# Access Compliance Report

## Public Rights-of-Way

Intersection ID: 32317	Main Street: BRIDGEVIEW_LN	Cross Street: NEW_PROVIDENCE_LN	Location: NW
ADA ID: BFF3B60F8A5F	Ramp Type: PerpDiag	Initial Pass/Fail: Fail	Overall Compliance: No
		Severity Score: 25

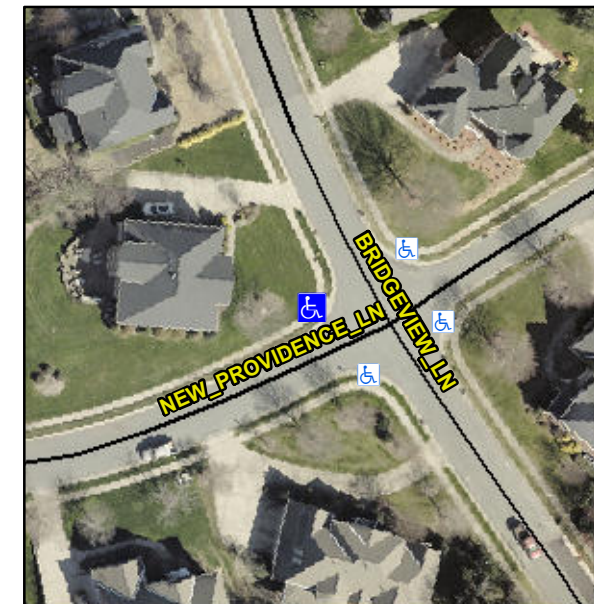
**Not Found, R304.2.2, R304.5.3**

Compliance	Description	Data	Compliance	Description	Data
N/A	Ramp Length (in)	45.5	No	Ramp Slope (%)	9.4
Yes	Ramp Width (in)	48.0	No	Ramp XSlope (%)	6.2
N/A	Flare Type LT	N/A	N/A	Flare Type RT	N/A
N/A	Flare Slope LT (%)	N/A	N/A	Flare Slope RT (%)	N/A
N/A	Flare Traversable LT?	N/A	N/A	Flare Traversable RT?	N/A
N/A	Landing Length (in)	N/A	N/A	DWS Provided?	N/A
N/A	Landing Width (in)	N/A	N/A	DWS Contrast?	N/A
N/A	Landing Slope (%)	N/A	N/A	DWS Length (in)	N/A
N/A	Landing X Slope (%)	N/A	N/A	DWS Full Width?	N/A
N/A	Landing Curb? (Y/N)	N/A	N/A	DWS Offset (in)	N/A
N/A	Shared Landing?	N/A			
N/A	Gutter Ponding?	N/A	N/A	Gutter Slope (%)	N/A
N/A	Gutter Lip Ht (in)	N/A	N/A	Gutter X Slope (%)	N/A
N/A	Painted X Walk1?	No	N/A	Painted X Walk2?	No
	X Walk 1 Direction	To S		X Walk 2 Direction	To NE
N/A	X Walk 1 Width (in)	N/A	N/A	X Walk 2 Width (in)	N/A
	X Walk 1 Slope (%)	5.5		X Walk 2 Slope (%)	4.0
	X Walk 1 X Slope (%)	2.1		X Walk 2 X Slope (%)	7.4

**Remove & Replace Curb Ramp With Two New Directional Ramps or Equivalent.**
